ADCO ITP Documentation

Trade Discipline: FRP

UGF Pour 1

PROJECT
TAFE NSW CONSTRUCTION CENTRE
OF EXCELLENCE
12-44 O'CONNELL ST,
KINGSWOOD NSW 2747

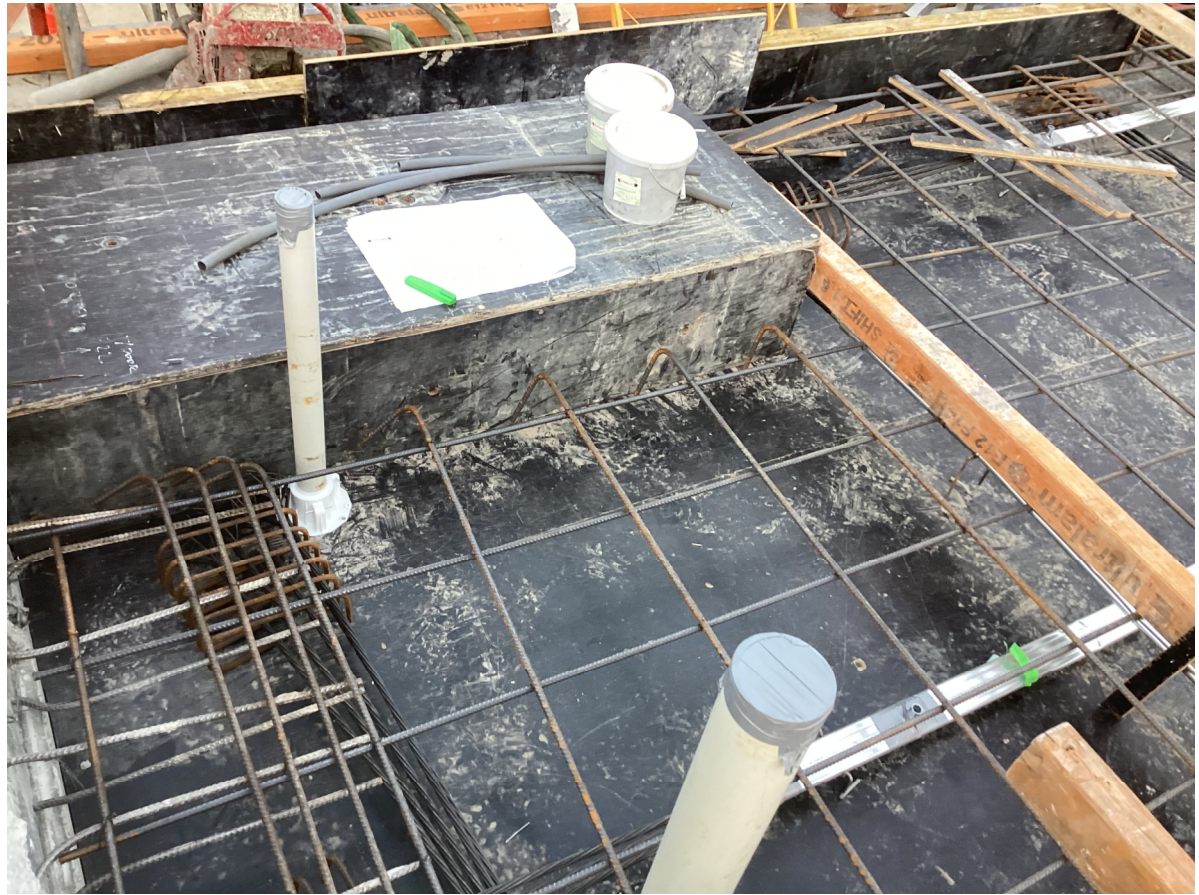
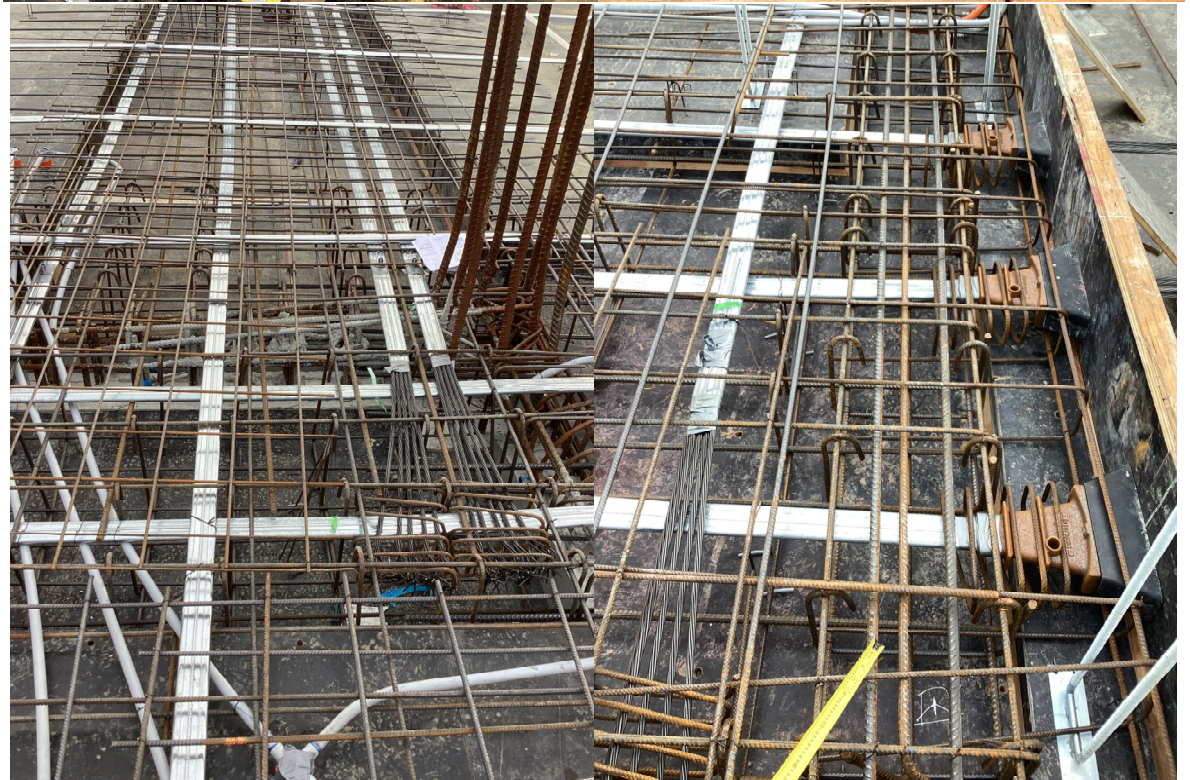
Steel is 10mm higher than finished floor level Toby box steel 15mm high Step down to 20 mil too high Formworker will have to jackhammer around setdown and repair as discussed with Rob the foreman from ADCO

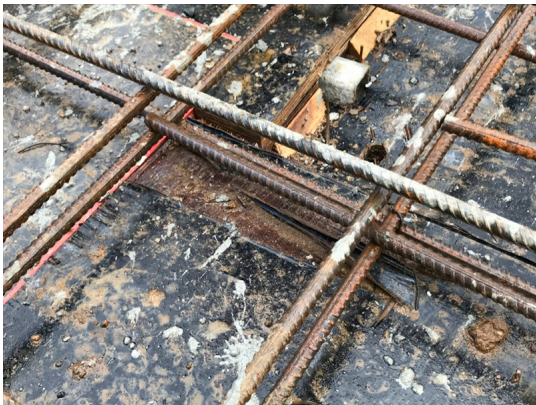
Deck left dirty, will leave a stain in the slab Peno mesh exposed Damaged Formwork tables on slab ADCO informed TGA to give fall to floor waste- not shown on plan No top mesh provided in some area of the beams Formworkers stripping legs early, Timbers have dropped Formwork blowout, poorly braced

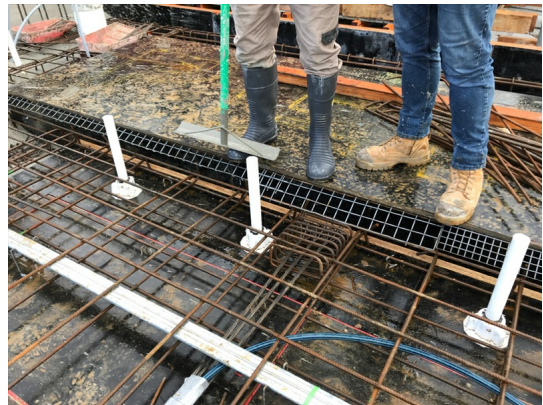
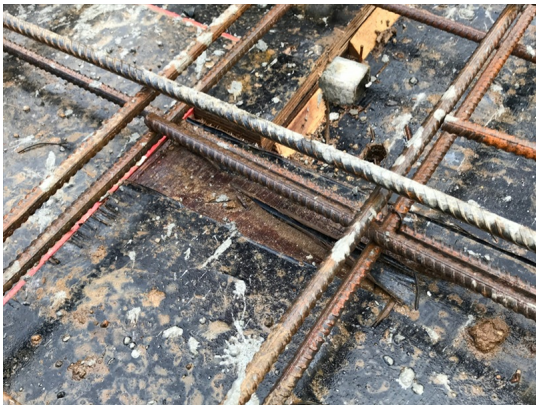
Deck left dirty, will leave a stain in the slab Peno mesh exposed Damaged Formwork tables on slab ADCO informed TGA to give fall to floor waste- not shown on plan No top mesh provided in some area of the beams Formworkers stripping legs early, Timbers have dropped Formwork blowout, poorly braced

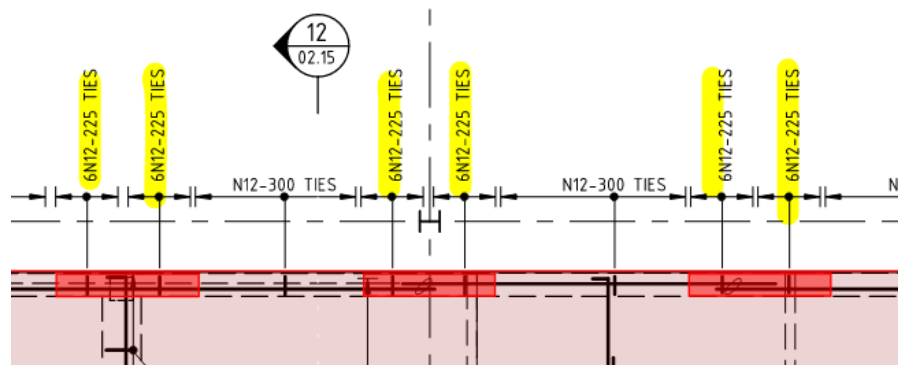
- 1) 1 N16 bottom bar not installed. Please install the additional bar and send photos for review and approval.

- 2) Closer spaced ties adjacent to walls and beam should have ties placed at 225 cts. If 225 is not achievable, please ensure ties are a maximum of 250 CTS. Send photos for review and approval.

Once the above-mentioned items have been completed, Northrop Engineers are satisfied that the above-mentioned items have been formed and reinforced generally in accordance with the design intent and concrete placement may proceed. ADCO are to provide photographic evidence to close out the items within this report.

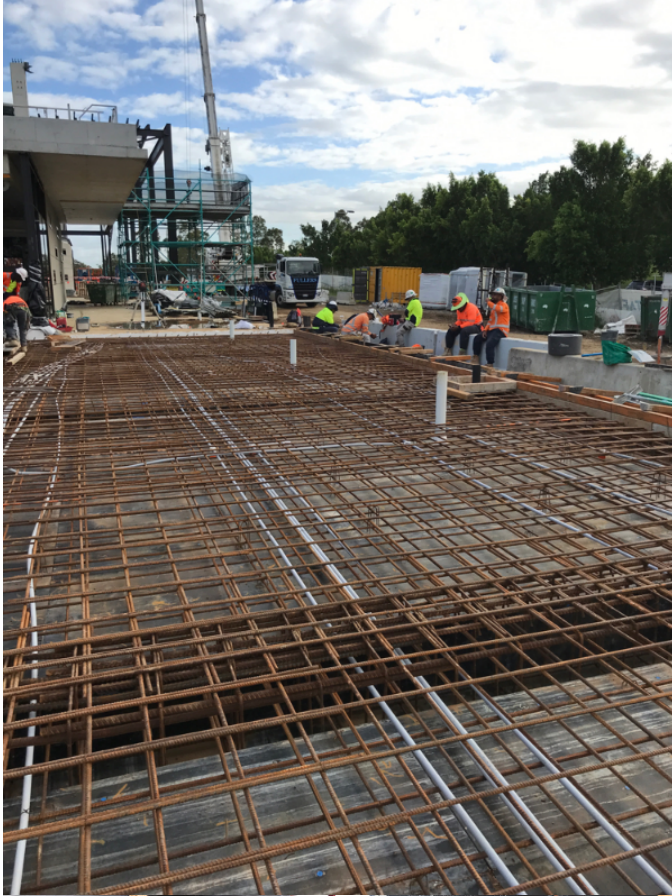
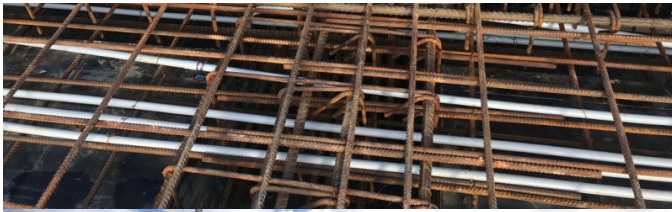
Check suitable method of placement and vibration. (Visual Check)	Inspection
Check required surface finish. (Against drawings/specifications)	Inspection
Check curing compound applied. Check AsBuilt survey (To specification Safety Cure WB)	Action
Comments	1x Column in slab Underside of Hob lifted 35mm
Photos
